**SUBJECT: REVISION "A" TO TECHNICAL BULLETIN 214ST-04-174:  
SCISSORS AND SLEEVE ASSEMBLY, SLEEVE UPPER NUT,  
P/N 214-010-418-001, ADDITIONAL MAINTENANCE MANUAL  
INSPECTION REQUIREMENTS.**

No. 214ST-04-174

REV A
-------

**SUBJECT:** **SCISSORS AND SLEEVE ASSEMBLY, SLEEVE UPPER NUT, P/N 214-010-418-001, ADDITIONAL MAINTENANCE MANUAL INSPECTION REQUIREMENTS.**

FIGURE 1

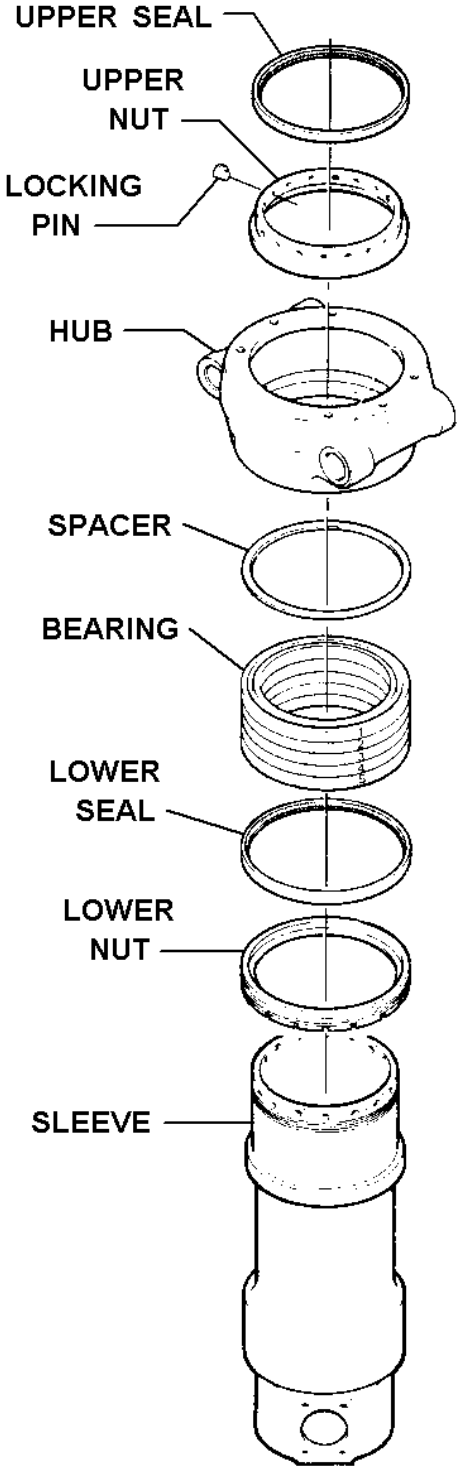
Revision "A" to this bulletin adds a note concerning upper nut thread direction on page 3 and in Figure 1.

The upper nut has left hand threads.

TORQUE CHECK UPPER NUT PER TEXT

UPPER NUT HAS LEFT HAND THREADS

- b. Using the wrench assembly portion of the T101709 Wrench set, verify torque on hub upper nut is between 350 to 450 foot-pounds.
